IGNITION SYSTEM

OUTLINE OF CHANGE

Due to the changes on the spark plug of the 6G74-GDI engine and to the addition of the vehicles for Singapore, the following service procedures have been established.

SPARK PLUG CHECK AND CLEANING

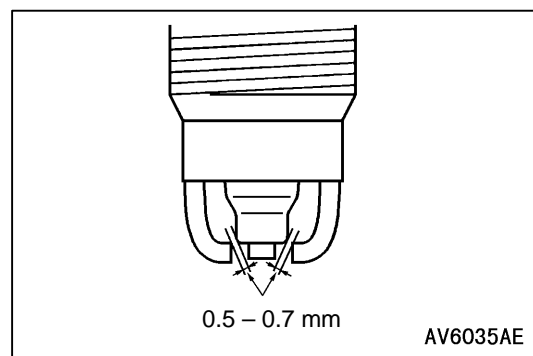
1. Remove the ignition coils.
2. Remove the spark plugs.
3. Check the spark plug gap. Adjust or replace it if the gap is not within the standard value.

Standard value: 0.5 – 0.7 mm

4. Remove carbon deposits with wire brush or plug cleaner.
5. Clean the spark plug holes.
6. Install the spark plugs.
7. Install the ignition coils.
